## Access Compliance Report Public Rights-of-Way (Curb Ramps)

Intersection ID: 14018 Main Street: BAY\_ST Cross Street: WESTOVER\_ST Location: SE

ADA ID: 4E9A826E129D Ramp Type: PerpDiag Initial Pass/Fail: Fail Overall Compliance: No Severity Score: 1.25

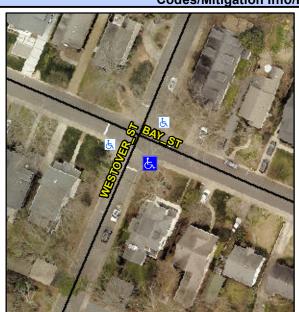
Not Found, R304.5.3

Remove & Replace Curb Ramp With Two New Directional Ramps or Equivalent.
